NORTHAMPTON
GATEWAY
STRATEGIC RAIL FREIGHT INTERCHANGE

STATEMENT OF COMMON GROUND BETWEEN THE APPLICANT AND RAIL CENTRAL (SIGNED)

DOCUMENT 7.17A

STATEMENT OF COMMON GROUND BETWEEN
THE APPLICANT AND RAIL CENTRAL (SIGNED) | NOVEMBER 2018

RAIL INTERCHANGE
ILLUSTRATIVE GENERAL
ARRANGEMENT
KEY PLAN

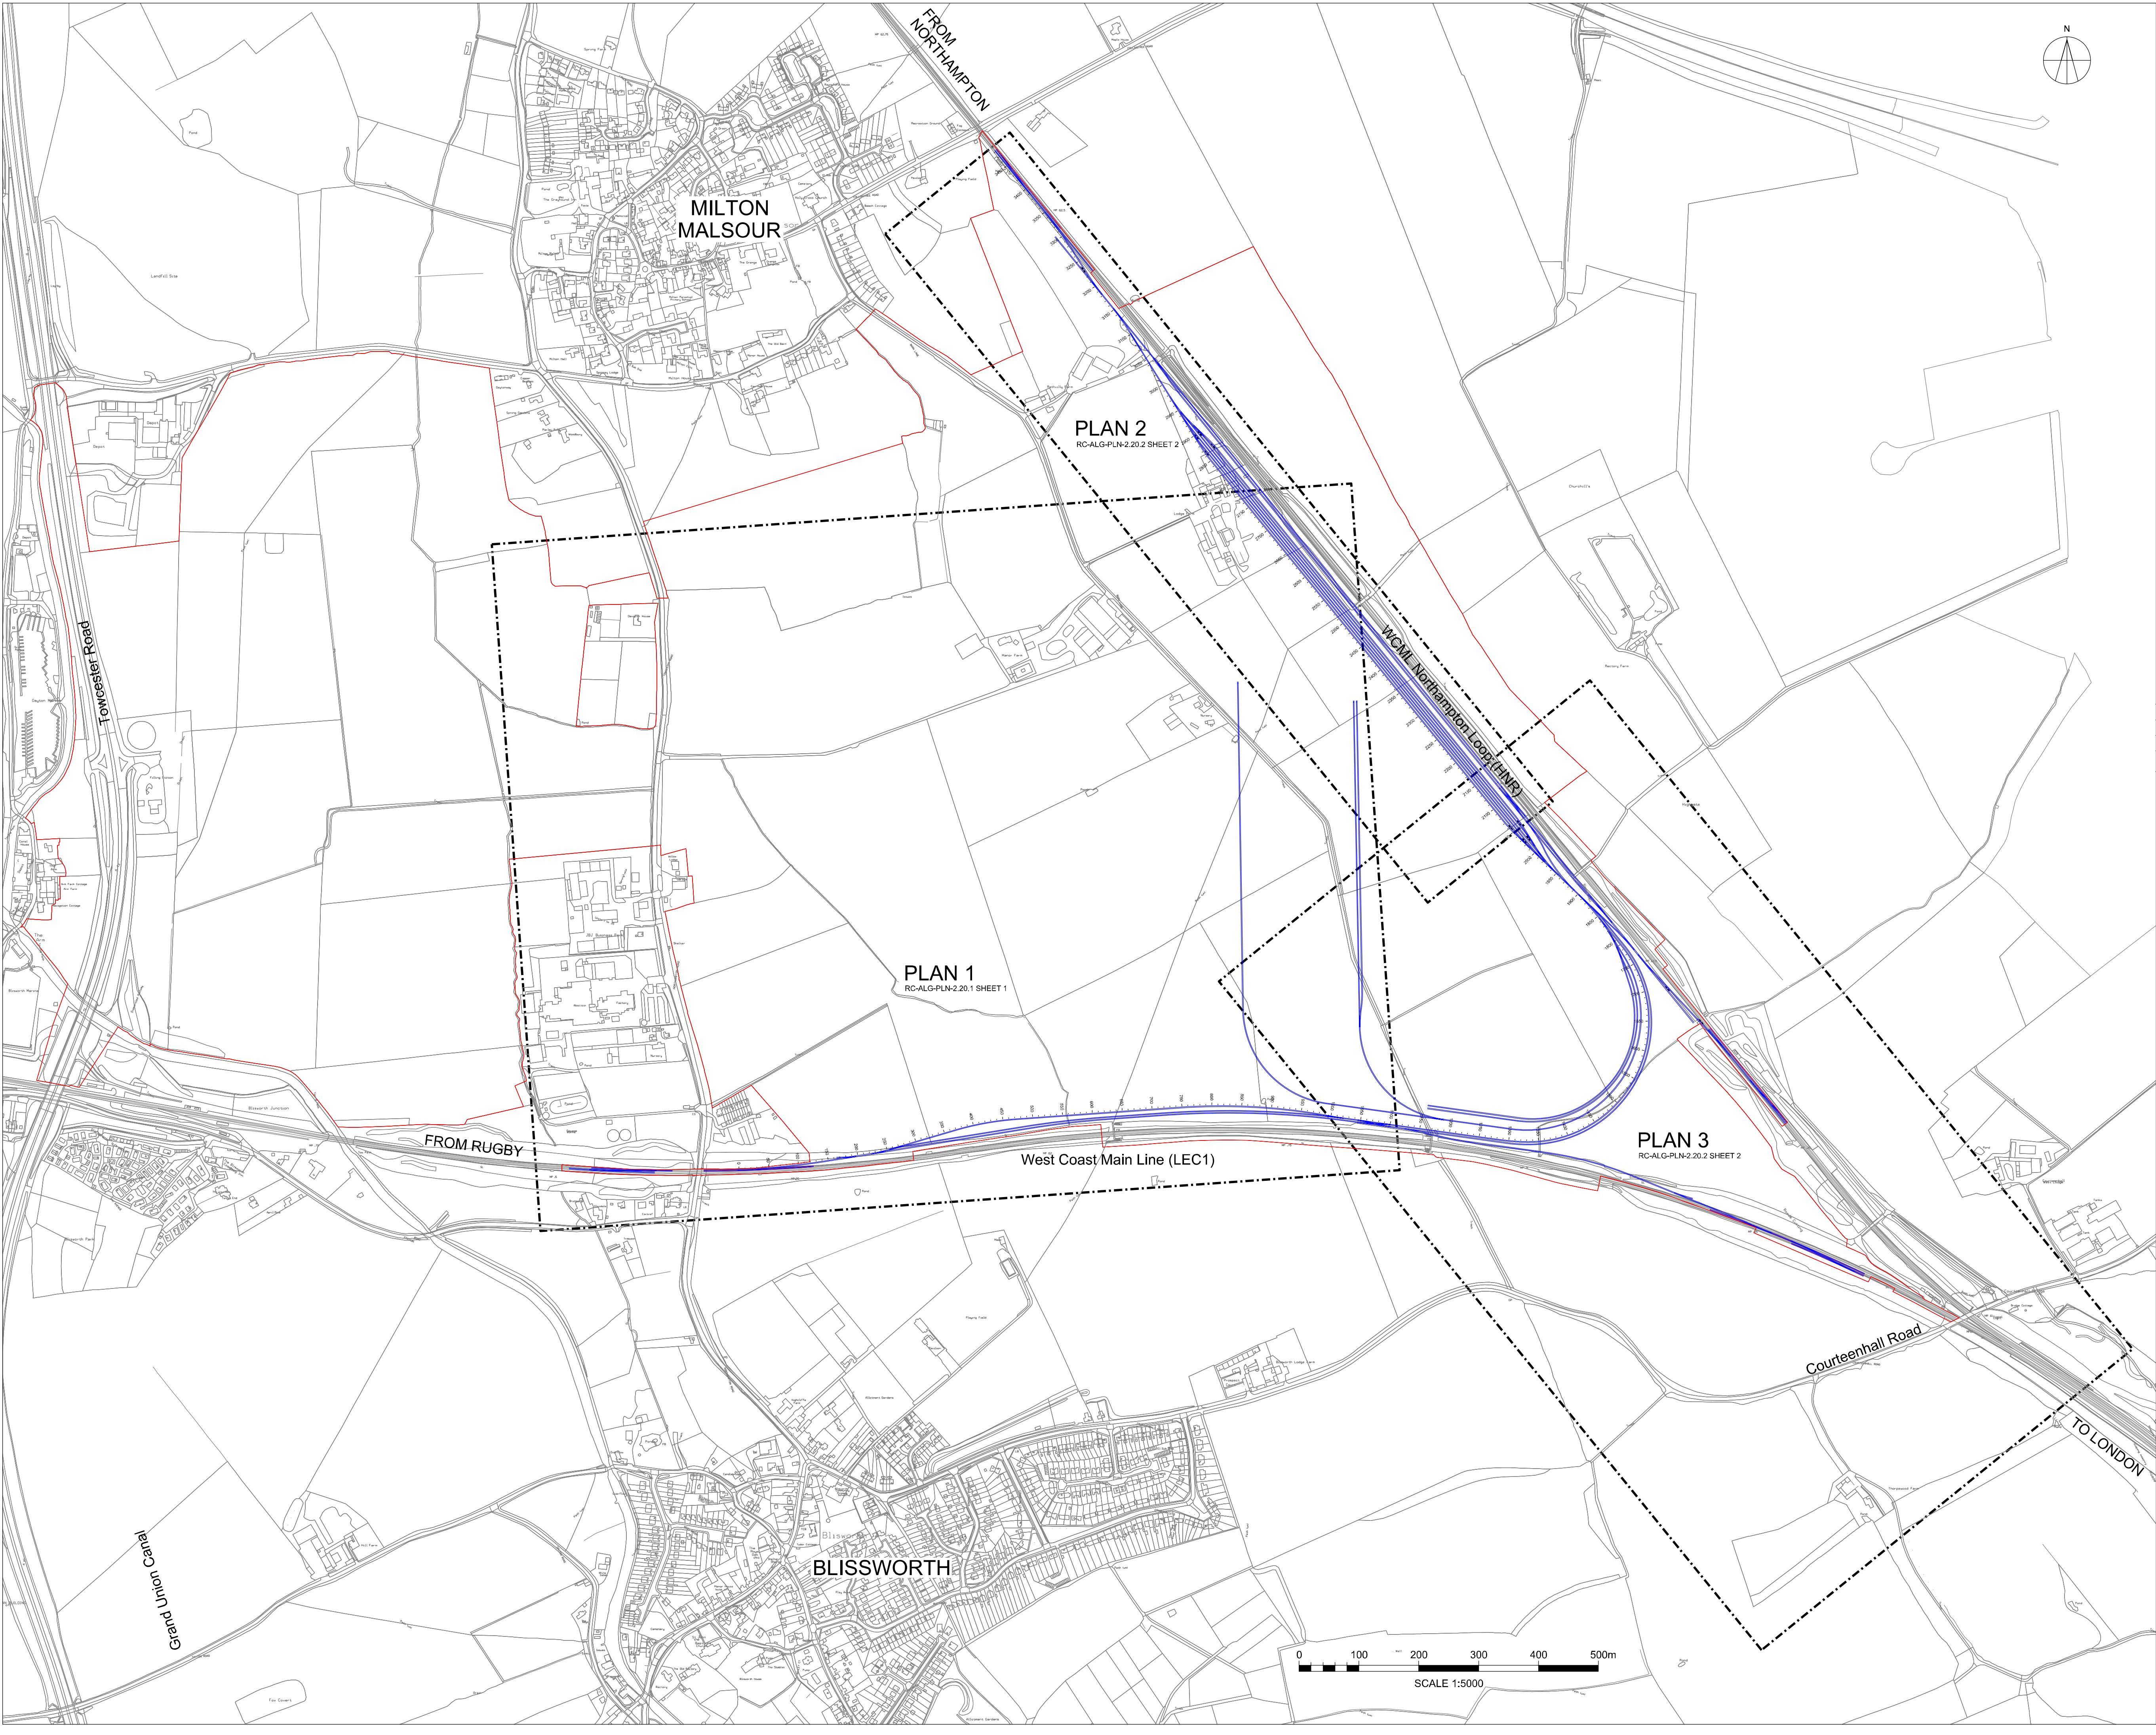
10. In the Interrelationship Document, paragraphs 4.1 to 4.9, Rail Central provide their views on compatibility of the two schemes. Roxhill, based on an initial view of the application documentation just submitted, do not agree that the two schemes as shown on the application plans are compatible.

11. Rail Central have stated in paragraph 3.2.1 of the Interrelationship Report that "Both Projects will be constructing new railway lines at the NLL to connect to their respective intermodal facilities. Configuration of connection points will be determined at detailed design stage in order to facilitate both connections".

12. However, the physical layouts of the network connections shown on the respective rail plans submitted are incompatible with the positioning of the southern connections being in the same location. This is not a conflict which can be left to the detailed stage because the repositioning of the south connections for either scheme would result in the lengthening of the junction which may take a scheme beyond Order limits and have implications on capacity and pathing. This is because entry and exit times will be extended and the amount of wrong direction running will be increased, thereby blocking both the Up and Down Northampton Lines for longer.

13. None of the schemes referred to in paragraph 4.2 of the Interrelationship Report are comparable situations.

14. Recent technical assessment of the respective main line connections onto the NLL (slow lines) indicates that an appropriate design solution can allow both sets of main line connections to be achieved within their respective order limits, without requiring any changes to the main line entry/exit speeds and adding less than 5 seconds of additional "wrong line" working for trains to and from the main line. It is considered that with detailed design the level of wrong line working could be further reduced. A common approach to signalling would allow both schemes to have the opportunity of higher speed entry and exit onto the main lines. Further

information on track and signalling design will be provided following review with Network Rail.

JUNCTION 15A
GENERAL ARRANGEMENT

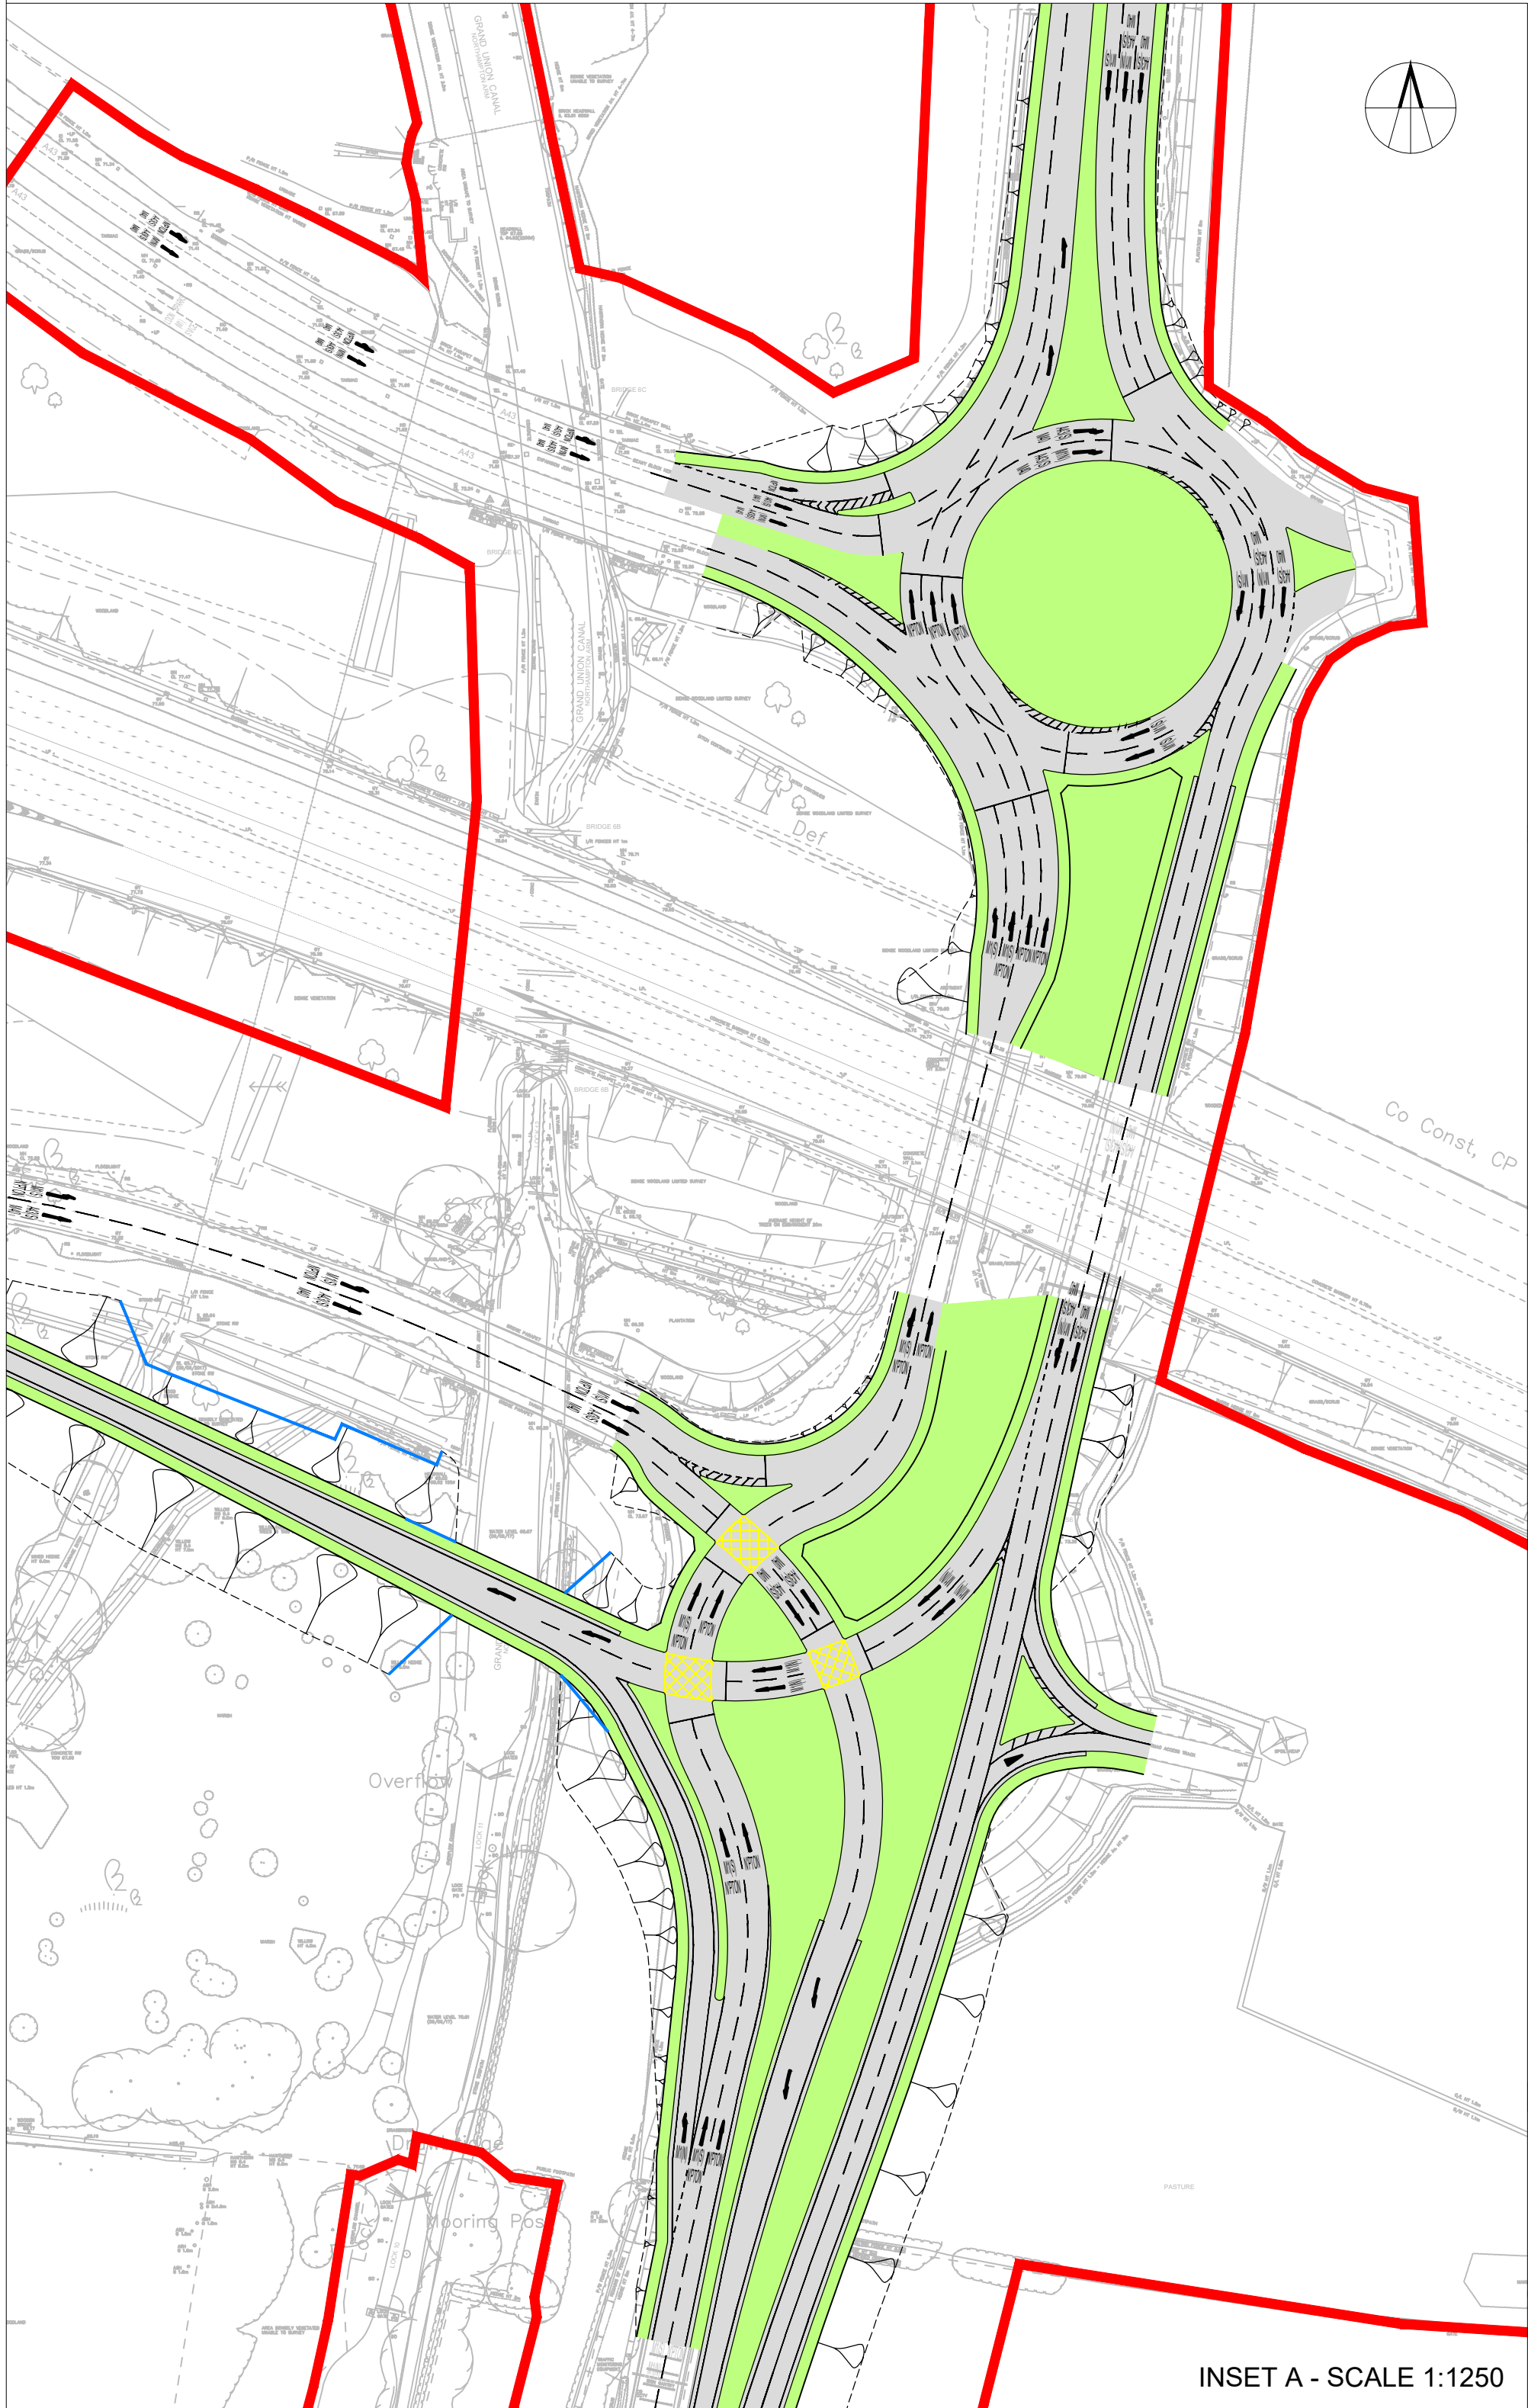
23. Paragraph 4.25 of the Interrelationship Report indicates that the Northampton Gateway draft DCO could be amended to "facilitate the option that [the Northampton Gateway Junction 15a works] may not be required in the event that the Rail Central Junction 15a works are undertaken". Roxhill agree that it would be appropriate to amend the Roxhill dDCO to ensure that the obligation on Roxhill to carry out the Northampton Gateway Junction 15a works no longer applies if the Rail Central Junction 15a works are undertaken, but only if the Rail Central Junction 15a works are sufficient to mitigate the impact of both schemes.

24. The works proposed by Rail Central to J15A in their application are different than those initially proposed by Rail Central upon which the work which informed the Northampton Gateway CIA was prepared. At the time of the preparation of the Northampton Gateway CIA Rail Central were proposing more extensive enhancements to J15a. This was prior to a subsequently smaller scheme being put forward by Rail Central with its Stage 2 Consultation. The more extensive scheme was modelled and the outcome included in the CIA. The Stage 2 consultation scheme came too late to be modelled and any outcome included within Northampton Gateway's CIA, however the amended mitigation proposals were referred to.

25. Roxhill is in the process of examining the Rail Central application and is not in a position to conclude that such the approach outlined in paragraph 23 above is appropriate until it has had the opportunity to understand fully the effect of the revised Rail Central highway mitigation strategy. The review of the recent application, carried out to date, suggests that the works now proposed at Junction 15A may not be sufficient to accommodate the traffic impact of the Rail Central proposals alone and therefore not sufficient to accommodate the cumulative impact, however this will be kept under review if further information is forthcoming from Rail Central in time to have regard to it in the CIA, which is to be delivered for Deadline 4. Roxhill will attend a meeting to discuss such information if it is forthcoming and if it will facilitate the provision of a best informed CIA by Deadline 4.

26. The modelling work undertaken as part of the junction design for Rail Central indicates that Rail Central's proposed design for Junction 15a increases capacity sufficiently to deal with increased traffic flow that results from the Rail Central development coming forward on its own, or from the cumulative traffic loading from both Rail Central and Northampton Gateway should they both be granted consent. Rail Central has proposed a technical meeting between experts to further address the points made by Northampton Gateway within paragraphs 23 and 25 above.

27. Rail Central has also set out in the Interrelationship Report phasing scenarios to cover the events where either Rail Central or Northampton Gateway commence development of the Junction 15a works first or whether Northampton Gateway commence these works significantly in advance of Rail Central (paragraphs 4.24.1 - 4.24.3 of the Interrelationship Report). Protective Provisions to manage this can be contained for Highway England's benefit in the Northampton Gateway DCO alongside those sought within the Protective Provisions for the benefit of Rail Central.
